Block C Plot 11 First Street
Manchester

Stage 1 Road Safety Audit

PROJECT REFERENCE: 158834

Block C Stage 1-Road Safety Audit Mark-up Plan

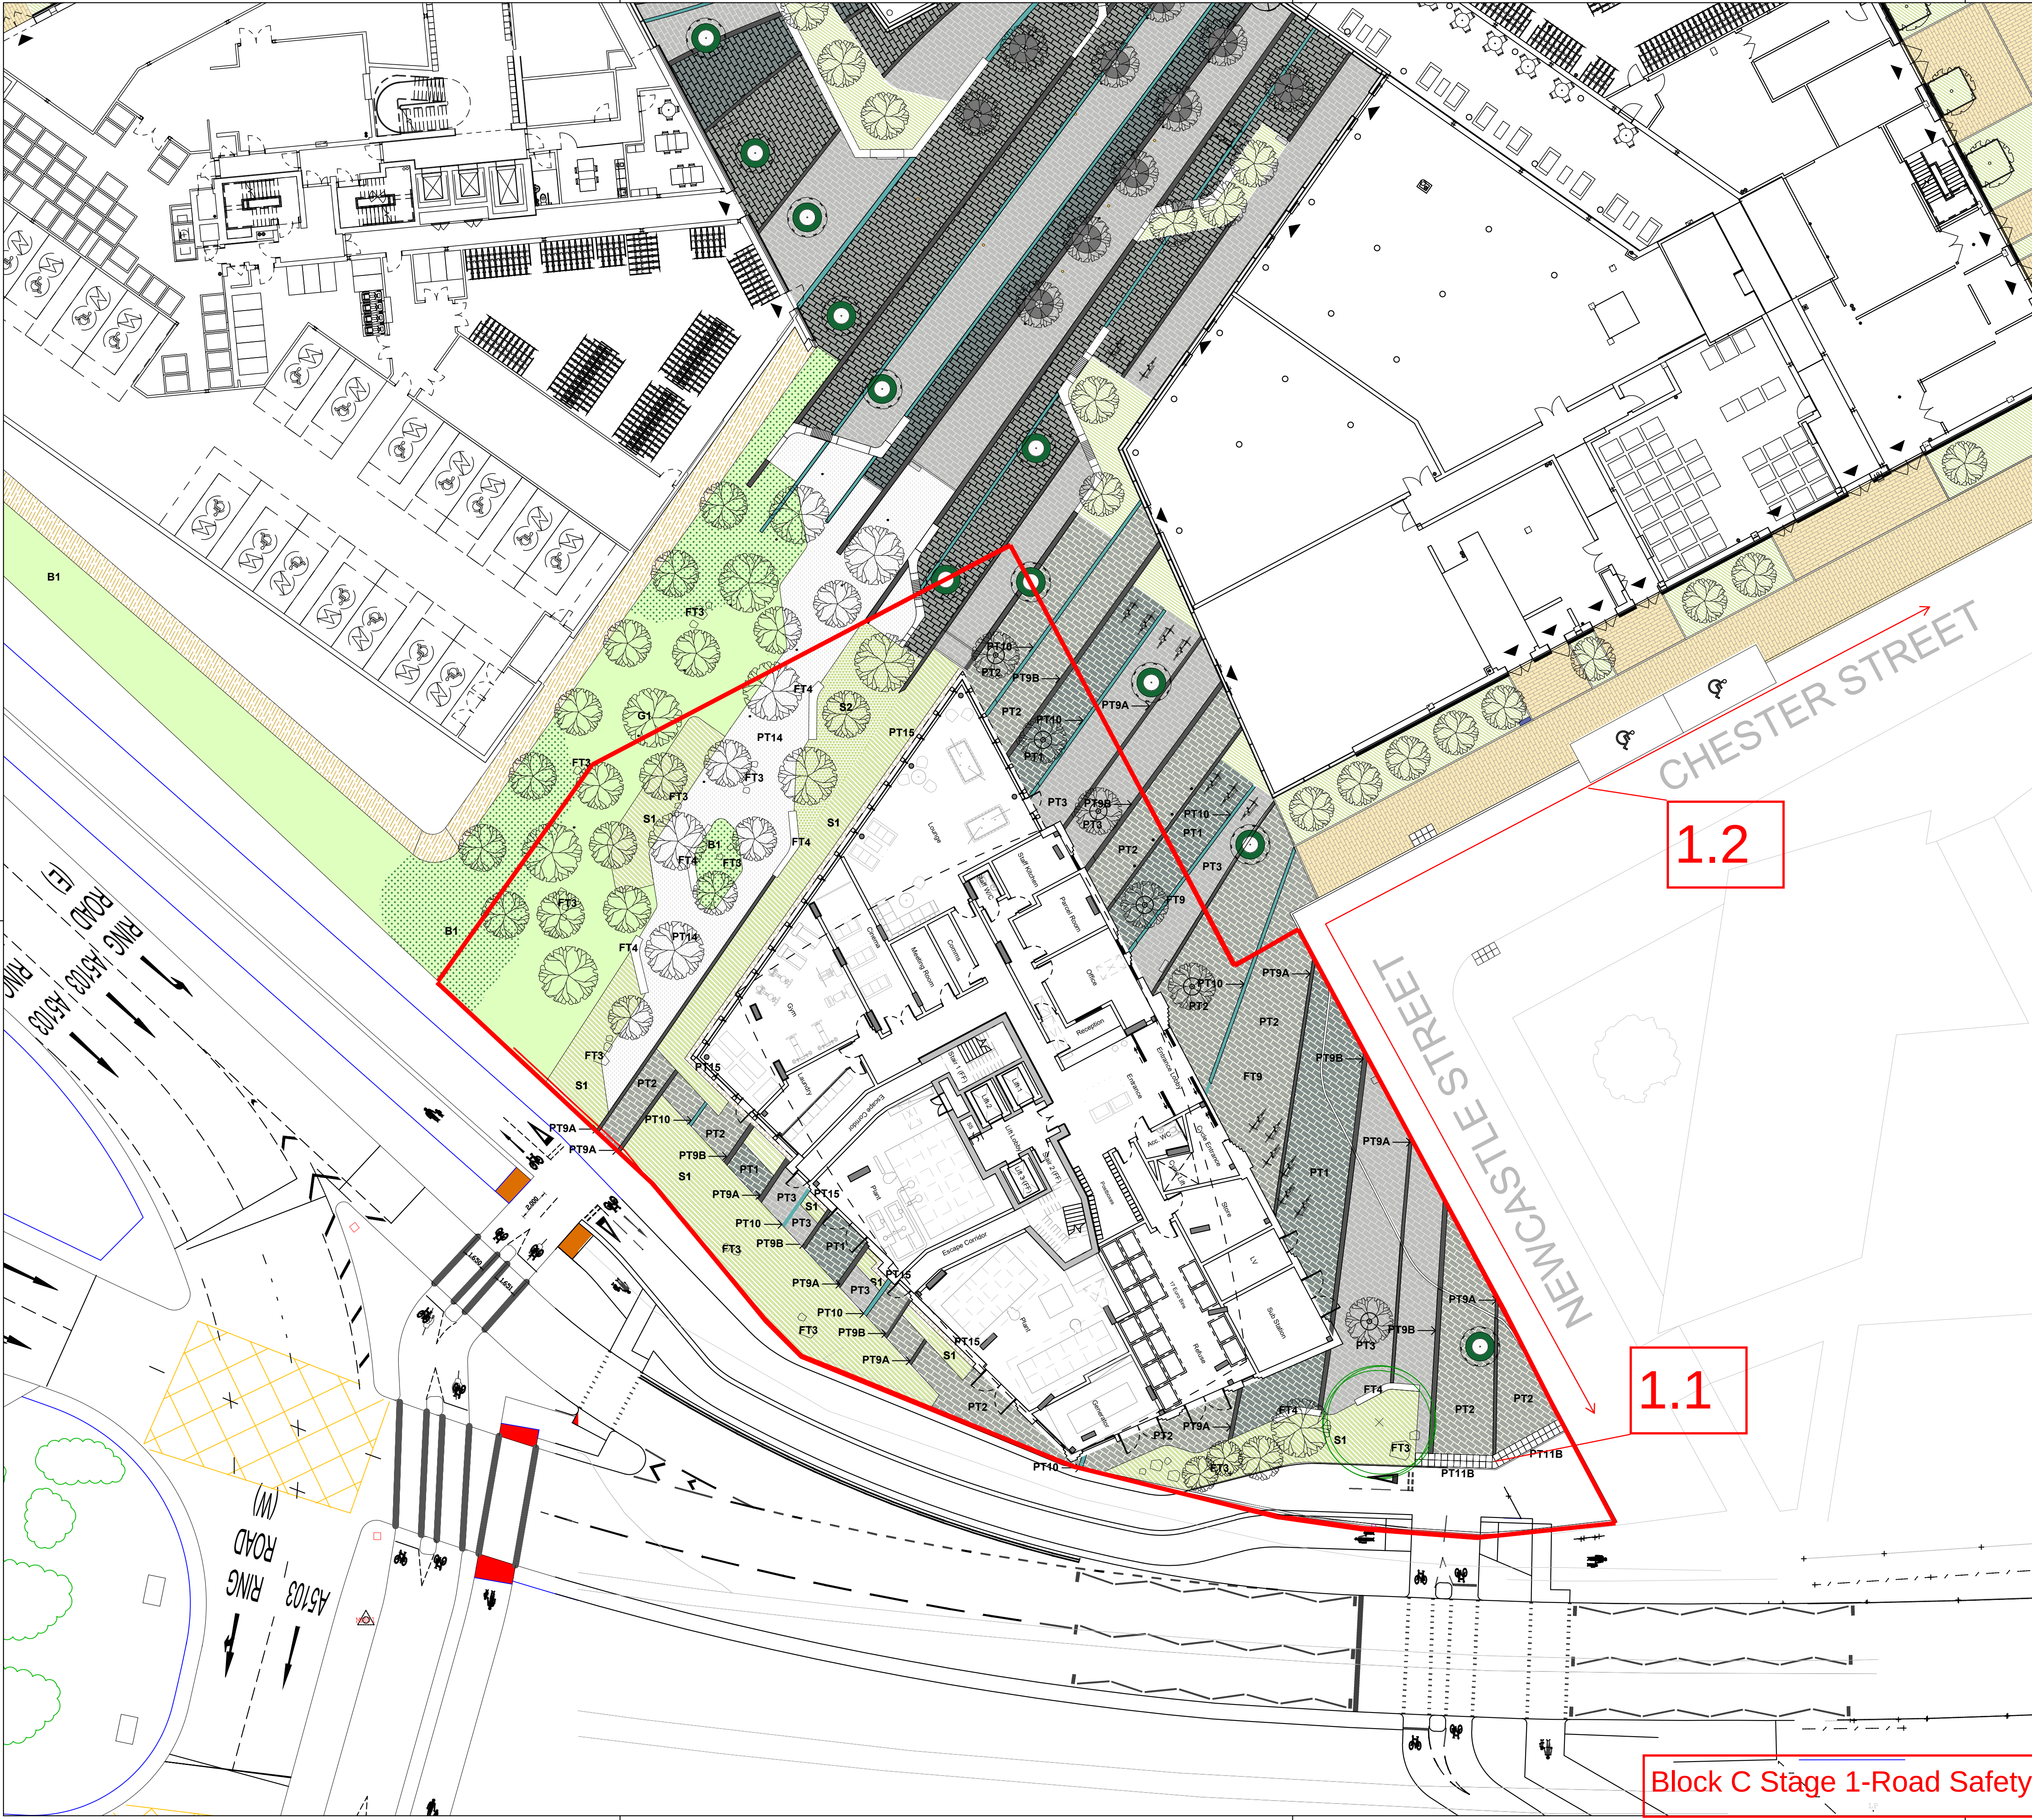
Problem 1.1:

Location: Newcastle Street adjacent to the A5103

Summary: The Landscape Plan drawing 10474-OPE-00-GF-DR-L-910001 revision 02 shows the provision of 'Blister' type tactile paving (annotation PT11B) between the proposed footway works and the existing cycle track to the south of the site. The segregated cycle track is nearest to the site and cyclists appear to join the Newcastle Street carriageway via a dropped kerb. It is not clear from the drawing whether the new hard surfaced route from the south, adjacent to the A5103 and running to the north into the site is intended as a shared use facility. There is signage for a cycle route along Newcastle Street / Chester Street. The priority between cyclists and pedestrians is not clearly defined in this area and 'blister' type paving is not appropriate as it does not have a reciprocal set of paving and in part would lead into the cycle track from the signalised crossing. This could lead to conflicts between cyclists and pedestrians where pedestrians cross the cycleway route to access the signalised crossing.

Recommendation: Provide appropriate pedestrian hazard warning paving and signage for cycle routing.

Problem 1.2:

Location: Western end of Chester Street

Summary: No details of street lighting have been provided on the drawings for the northern side of Chester Street. There are 2 existing street lights on Chester Street one on the southern side at the eastern end adjacent to Wilmott Street and one on the southern side adjacent to the junction with Newcastle Street. The next street light is on the southern end of Newcastle Street adjacent to the cycle track and the A5103. The development will lead to vehicles manoeuvring along Chester Street and Newcastle Street in conjunction with the signed cycle route as well as manoeuvring into the accessible parking bays together with an increase in resident footfall. Inadequate lighting levels could lead to the increased risk of conflicts between vehicles and also between vehicles and pedestrians.

Recommendation: Provide appropriate lighting levels on Chester Street Newcastle Street to accommodate the vehicle, cycle and increased pedestrian activity.

Designers Response Location 1.1

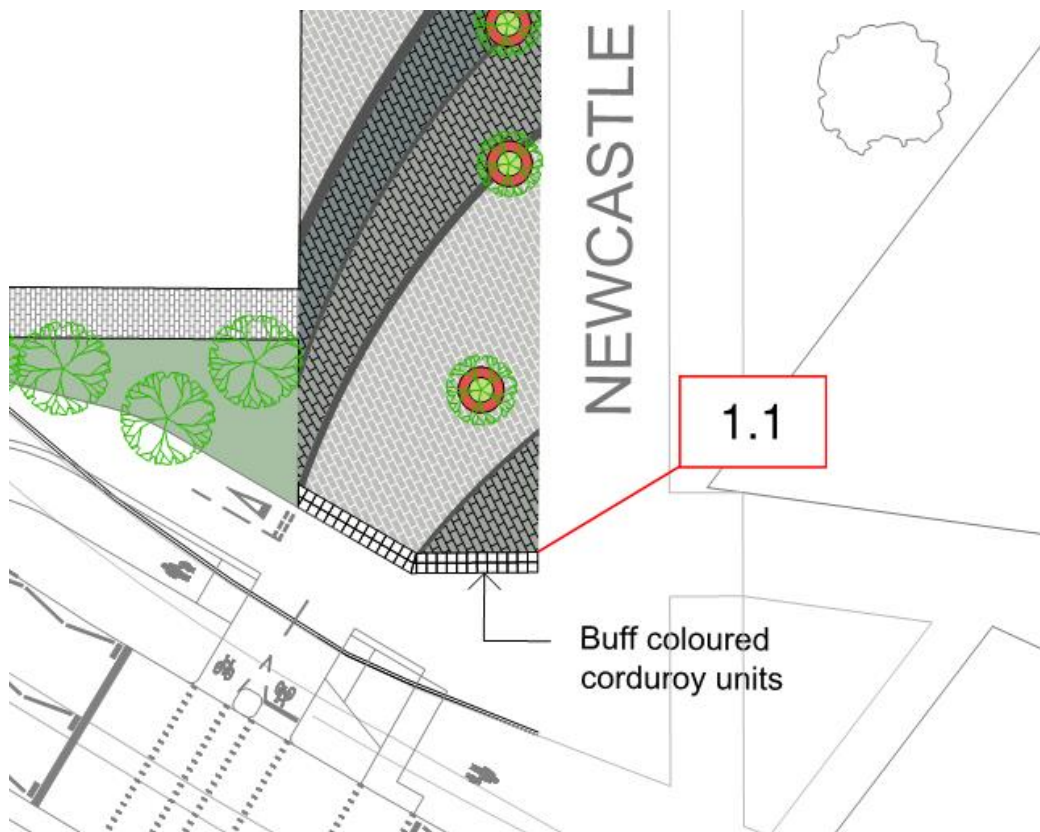
Problem 1.1:

Location: Newcastle Street adjacent to the A5103

Summary: The architects plan (M9083_L100 rev A) does not show the current highway pedestrian / cycle accommodation at the southern end of Newcastle Street adjacent to the A5103. Cyclists appear to join the Newcastle Street carriageway via a dropped kerb. There is a new cycleway / footway adjacent to the southern edge of the site and at the end of Newcastle Street associated with a signalised crossing facility over the A5103. This will link into the proposed pedestrian area along Newcastle Street (western side) where the priority between cyclists and pedestrians is not clearly defined. This could lead to conflicts between cyclists and pedestrians where pedestrians cross the cycleway route to access the signalised crossing.

Recommendation: Provide appropriate pedestrian hazard warning paving and signage for cycle routing.

Drawing 3732-D001 Rev B: S278 General Arrangement provides the following annotation and does not show the existing footway / cycleway features (See Image 1 below).
 APPROPRIATE CORDUROY/TACTILE PAVING AND SIGNAGE TO BE INSTALLED AS PART OF ON-SITE WORKS TO ENSURE ADEQUATE HAZARD WARNING FOR PEDESTRIANS CYCLISTS.

This area is outside the S278 Boundary shown on the drawing although noted as part of the on-site works. No further comments are made by the Stage 2 Audit Team with respect to the S278 highway works boundary.

Stage 1 Audit Designers Response: The recommendation is agreed. Pedestrian hazard warning paving and signage for cycle routing will be provided. The extract location 1.1 from the plan at **Appendix C** shows the proposed location for the hazard warning paving. The agreed Stage 1 Road Safety Audit recommendations are to be incorporated at detail design stage and subject to Stage 2 Road Safety Audit. The proposed measures to address the Road Safety Audit recommendation have been discussed with the Road Safety Audit Leader who is satisfied that the proposed measures adequately address the Road Safety Audit problem raised.

Designers Response Location 1.2

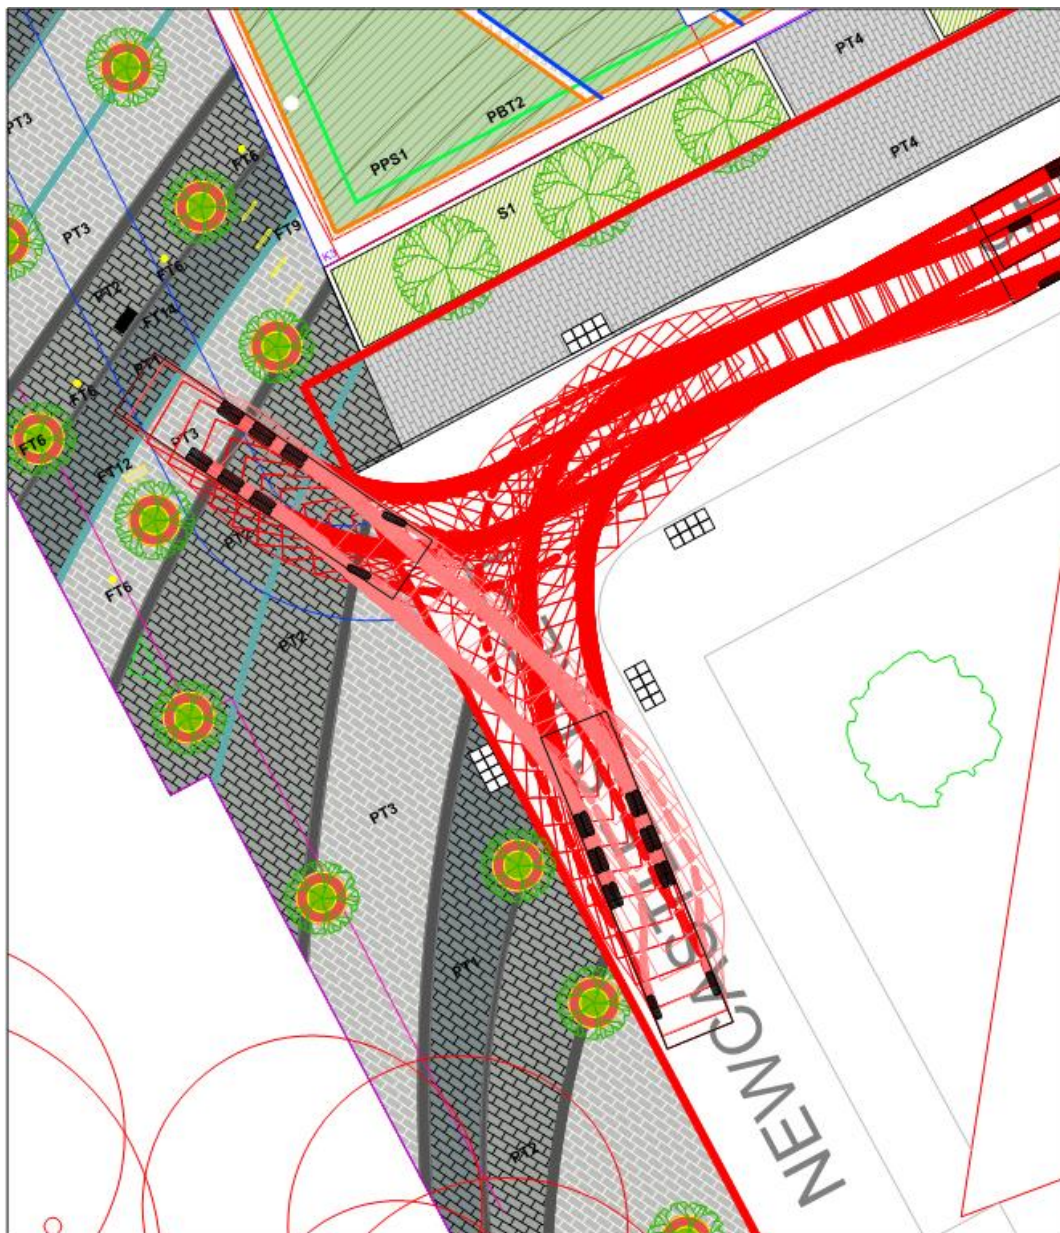
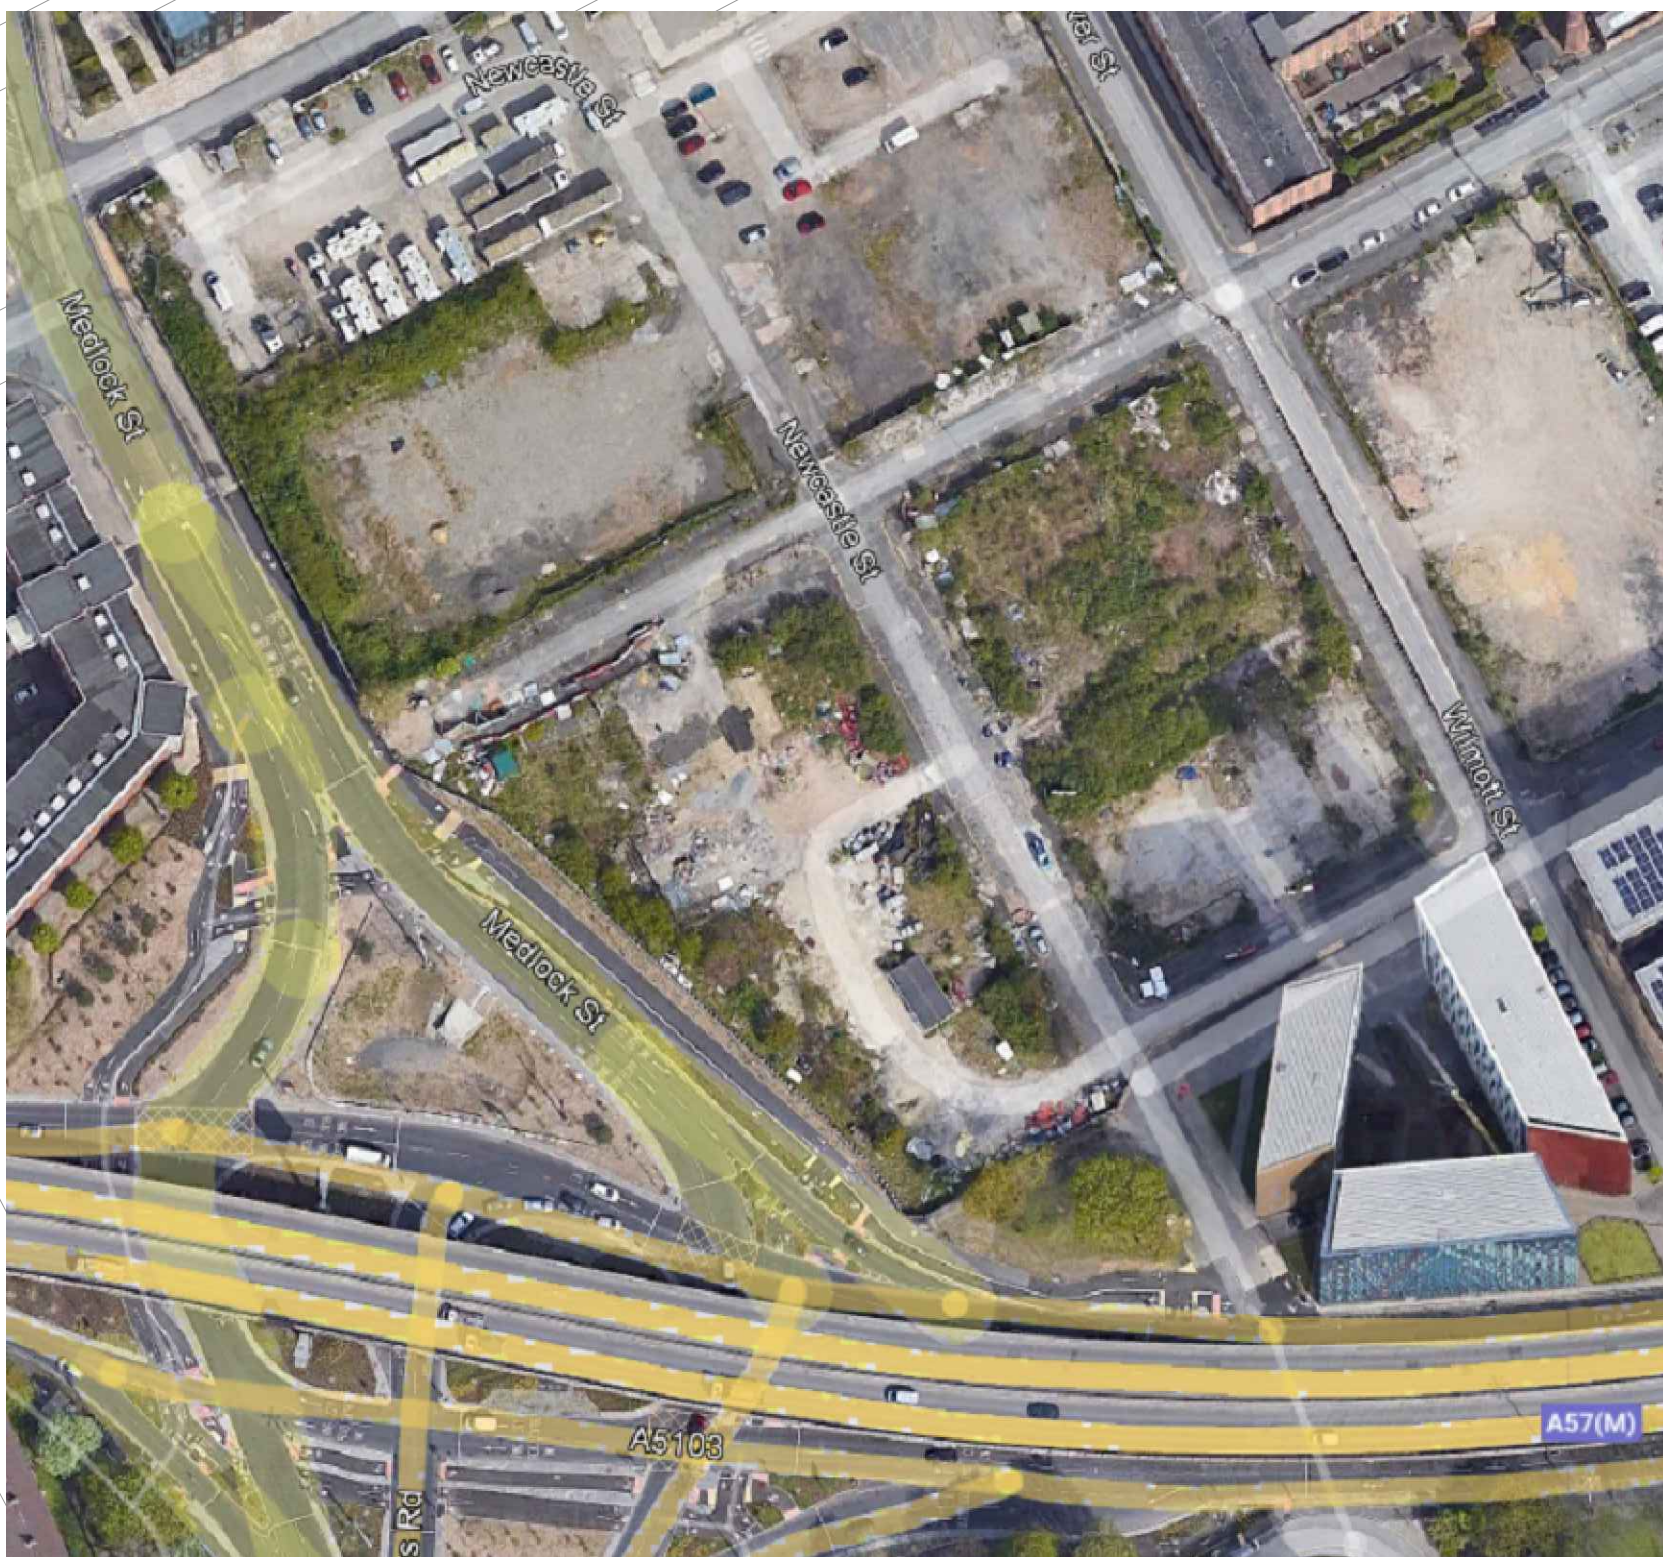
Problem 1.2:

Location: Newcastle Street junction with Chester Street

Summary: Drawing ref 300035-001: Swept Path of an 11.85m Refuse Vehicle shows a refuse vehicle turning at the western end of Chester Street at its junction with Newcastle Street where the existing carriageway width is to be reduced. The swept path is very constrained and utilises the proposed footway area on the west side and takes place where pedestrian dropped kerbs and tactile paving are provided. It is unclear if the refuse vehicle also services the adjacent building and no bollards are provided to limit its incursion on to the pedestrian area. The vehicle body swept path is shown overhanging the footway on the northern and western sides where dropped kerb locations are proposed which could result in conflict between the turning vehicle and pedestrians waiting at the crossing point.

Recommendation: Provide appropriate carriageway kerb widths locally or reposition the dropped kerb locations outside of the swept path but still on the likely pedestrian desire line.

Drawing 3732-D001 Rev B: S278 General Arrangement shows the proposed carriageway width of Chester Street is 7.3m and 4.8m for Newcastle Street. Drawing 3732-SP01: Swept Path Analysis shows the swept paths of 3 vehicle types. The swept path of the refuse vehicle appears to impinge over the tactile paving on the northern side of Chester Street which could result in conflict between a turning vehicle and pedestrians waiting at the crossing point. Problem 1.2 does not appear to have been fully addressed in the manner stated in the design team response despite the Chester Street carriageway being wider than stated in the Design Team Response.

Recommendation: Provide appropriate carriageway kerb widths and a swept path to demonstrate that the vehicle does not impinge over the tactile paving.

Stage 1 Audit Designers Response: *The recommendation is agreed. The proposed carriageway width on Chester Street adjacent to the site frontage has been widened from ~5.8m to ~6.7m. The widened carriageway better accommodates the refuse vehicle swept path, which does not encroach on the proposed footway area where pedestrian dropped kerbs and tactile paving*

are provided. The extract overleaf is taken from the swept path drawing 300035-001 Rev A at **Appendix D** which shows the refuse vehicle tracking on the revised proposals at Location 1.2 and also bollards and planters (labelled FT6 and FT14) provided to limit vehicle incursion on to the pedestrian area. The agreed Stage 1 Road Safety Audit recommendations are to be incorporated at detail design stage and subject to Stage 2 Road Safety Audit. The proposed measures to address the Road Safety Audit recommendation have been discussed with the Road Safety Audit Leader who is satisfied that the proposed measures adequately address the Road Safety Audit problem raised.
